**ADDENDUM NO. 02  
To Drawings and Specifications dated 02/07/2024**

**Date: FEBRUARY 07, 2024**

**PROJECT:** **Sequoia Elementary School HVAC Upgrade & Modernization  
A#04-121952**  
Westminster School District

10 FINISH FLOOR PLAN - BLDG "A-2"  
3/32" = 1'-0"

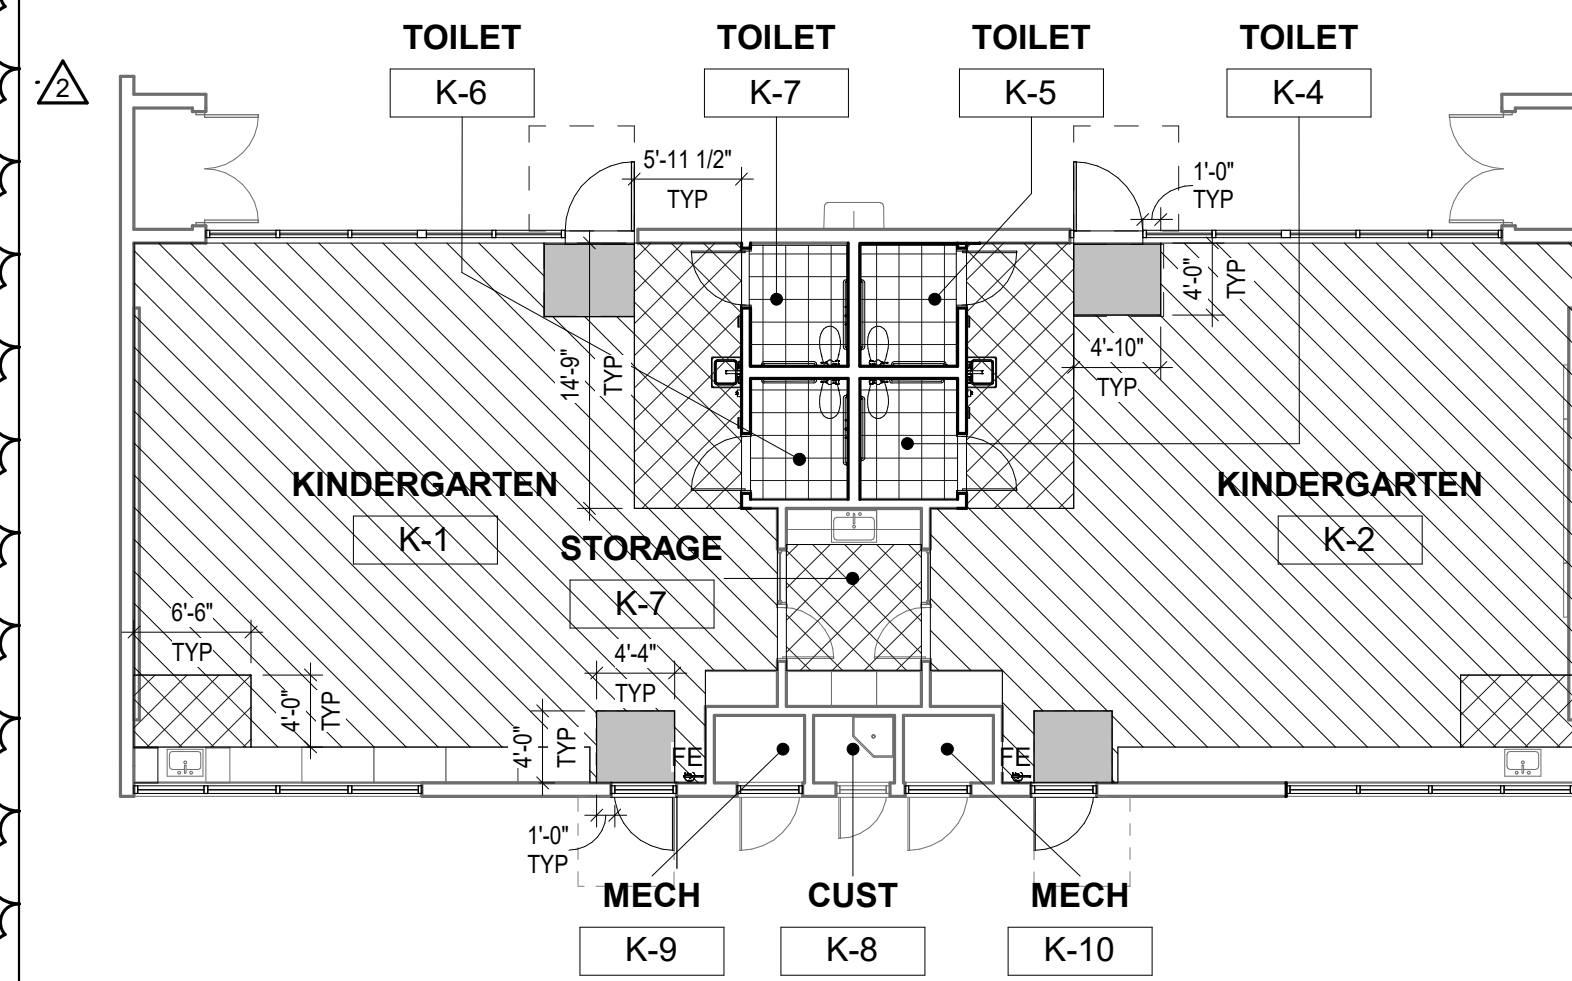
1. Detail – "Material Abbreviations"
  - a. Added "LVT – Luxury Vinyl Tile"
2. Detail – "Material Finish Abbreviations"
  - a. Added "LVT1 – Luxury Vinyl Tile 1, See Specifications"
3. Detail – "Finish Floor Materials Legend"
  - a. Revised "VCT-1" to "LVT-1, Luxury Vinyl Tile"
4. Detail – "Finish Schedule"
  - a. Revised schedule.
5. Detail "3 – Finish Floor Plan – BLDG ADMIN"
  - a. Revised "Finish Floor Plan."
6. Detail "6 – Finish Floor Plan – BLDG A-1"
  - a. Revised "Finish Floor Plan."
7. Detail "8 – Finish Floor Plan – BLDG A-3"
  - a. Revised "Finish Floor Plan."
8. Detail "10 – Finish Floor Plan – BLDG A-2"

- a. Revised "Finish Floor Plan."
- 9. Detail "12 – Finish Floor Plan – BLDG B-1"
  - a. Revised "Finish Floor Plan."
- 10. Detail "15 – Finish Floor Plan – BLDG B-3"
  - a. Revised "Finish Floor Plan."
- 11. Detail "17 – Finish Floor Plan – BLDG B-2"
  - a. Revised "Finish Floor Plan."
- 12. Detail "20 – Finish Floor Plan – BLDG C"
  - a. Revised "Finish Floor Plan."
- 13. Detail "23 – Finish Floor Plan – BLDG LAB/LIB"
  - a. Revised "Finish Floor Plan."
- 14. Detail "28 – Finish Floor Plan – BLDG K"
  - a. Revised "Finish Floor Plan."

2 FLOOR PLAN -BLDG ADMIN

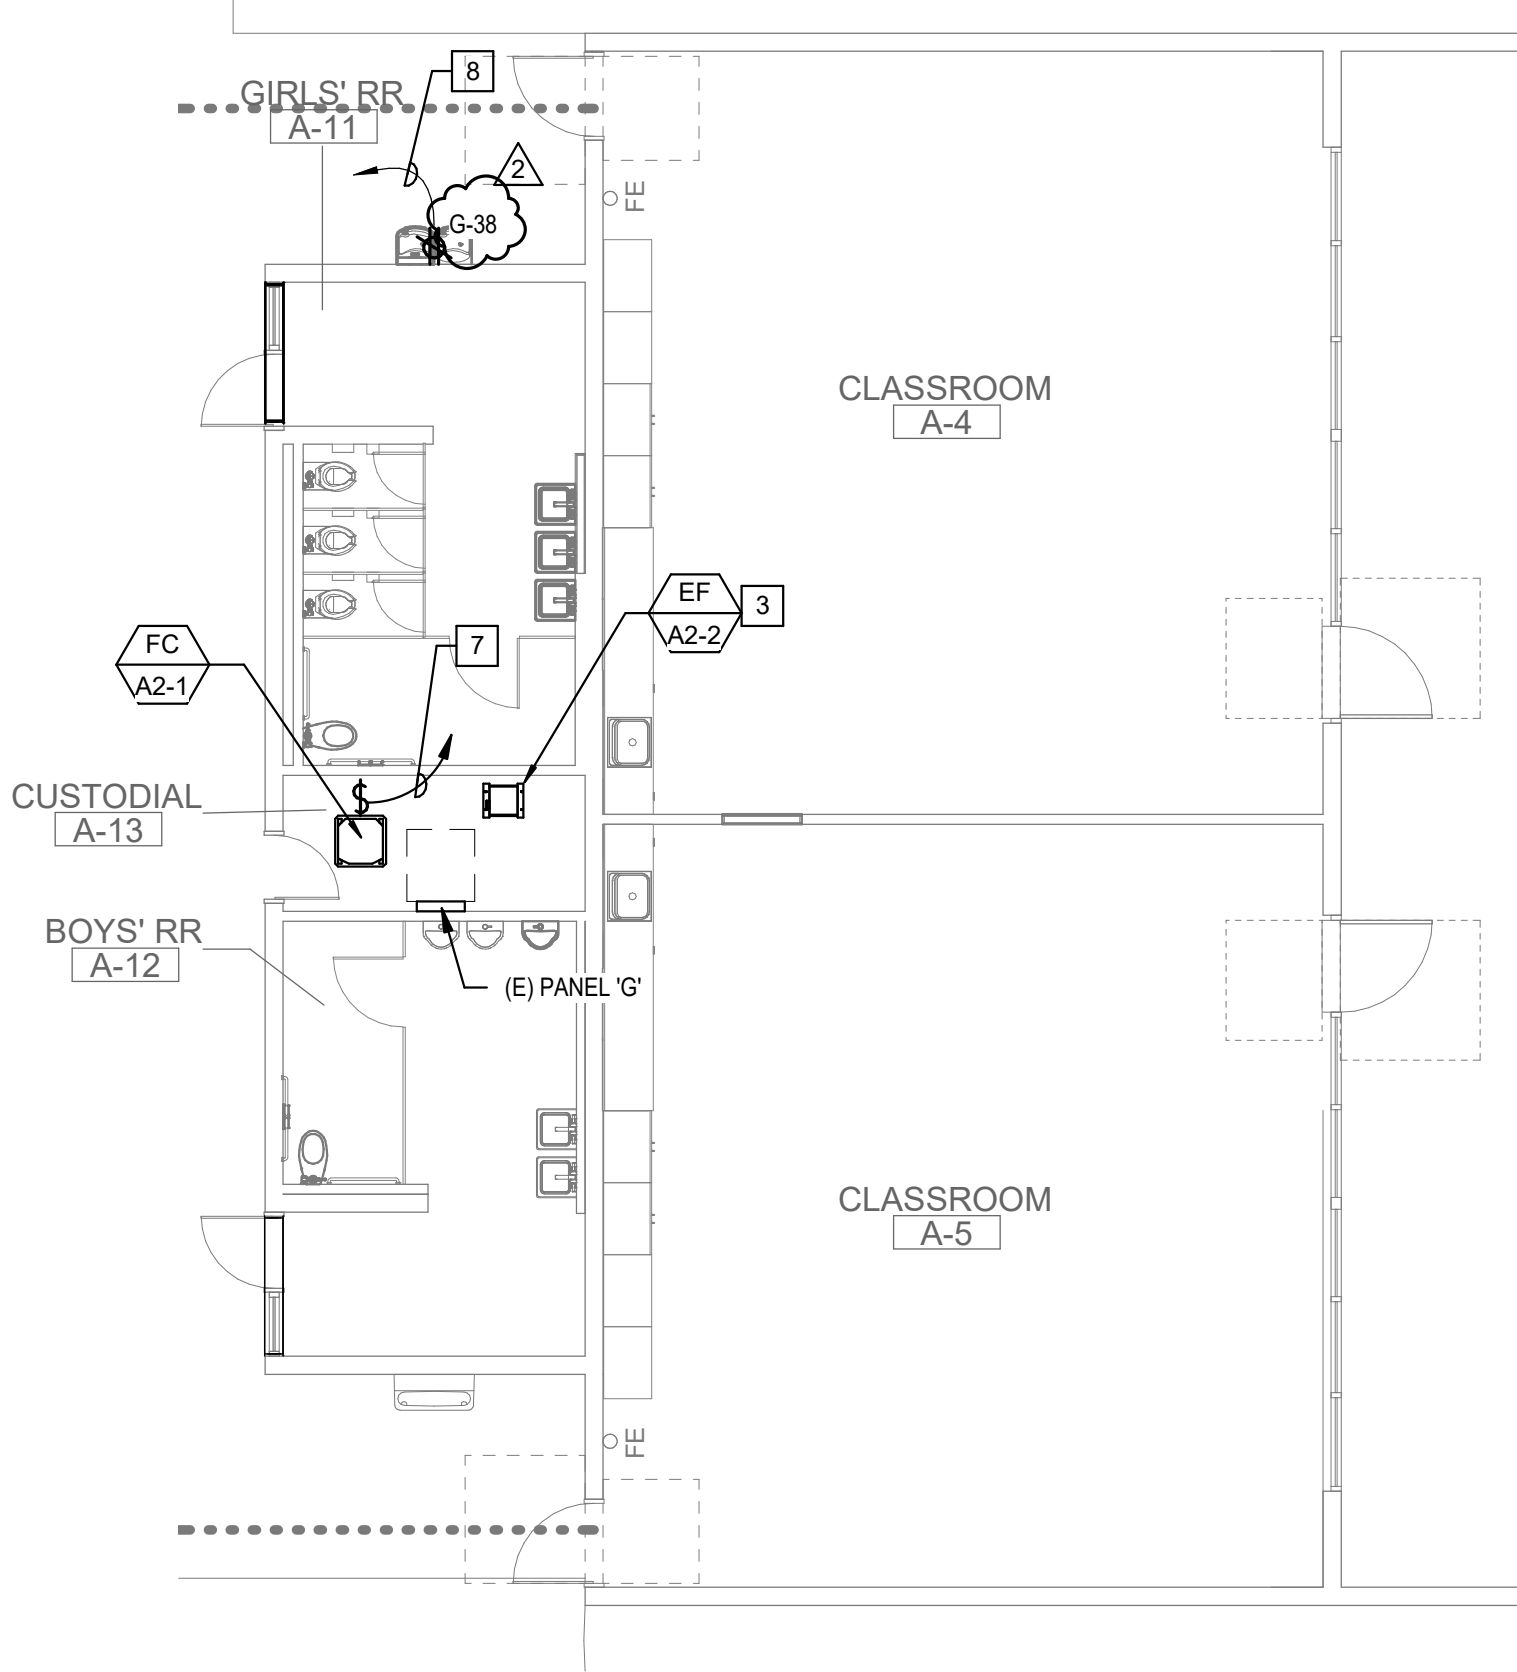
- 1. Detail No. 2: Admin Bldg.
  - a. Revised Keynote #5.

- b. Added power connection and disconnect switch to Electric Water Heater 'EWH-1.'

2 FLOOR PLAN -BLDG K  
1/8" = 1'-0"

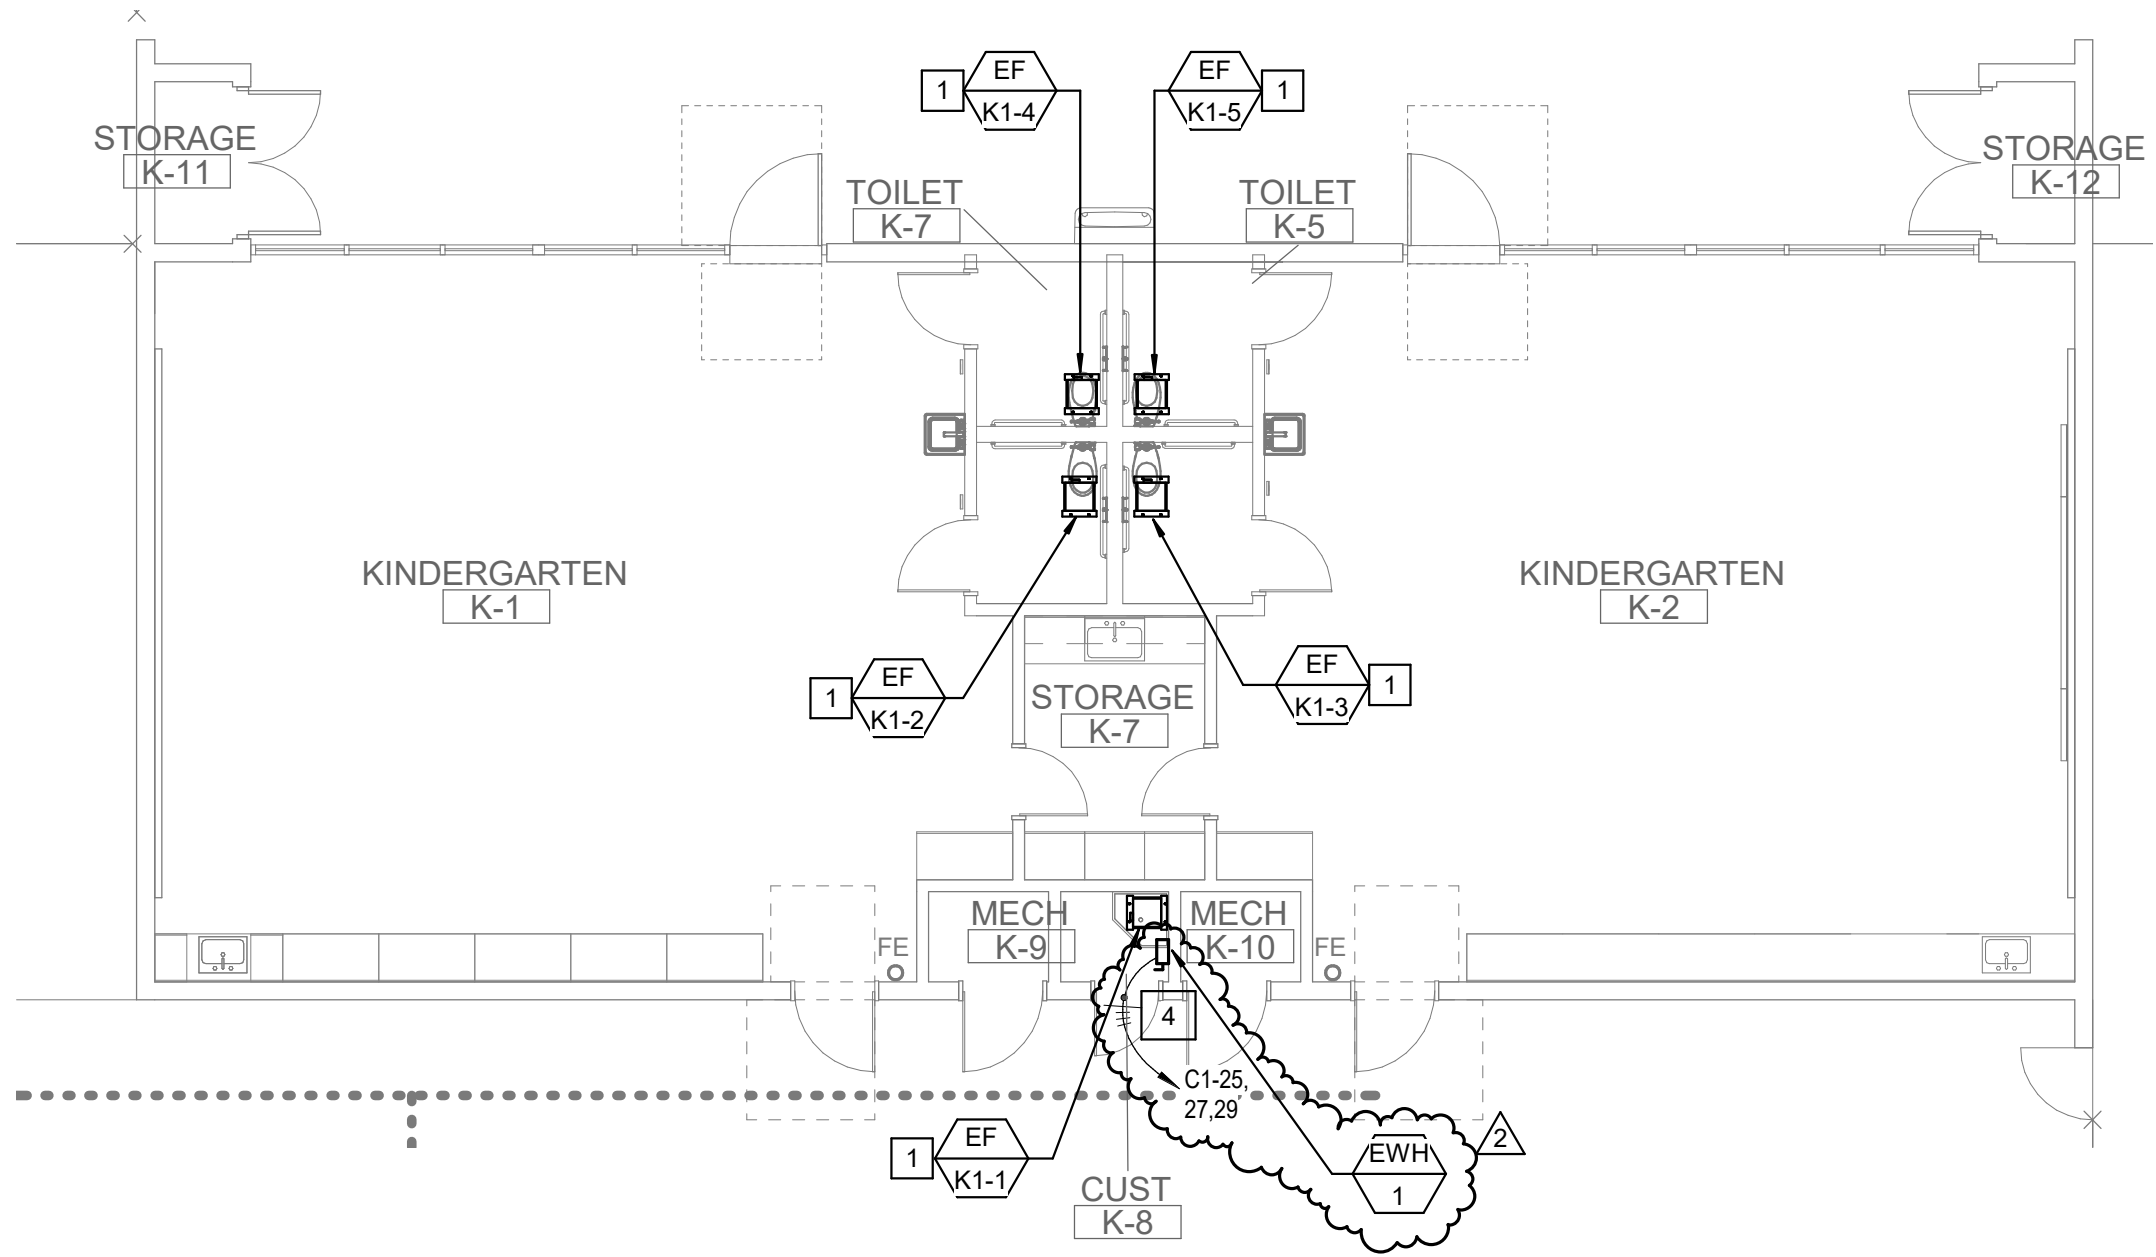
- 1. Detail No. 2: Bldg. K
  - a. Added keynote #4.
  - b. Added power connection and disconnect switch to Electric Water Heater 'EWH-1.'
- 2. Revised keynote #3 to "Not Used."
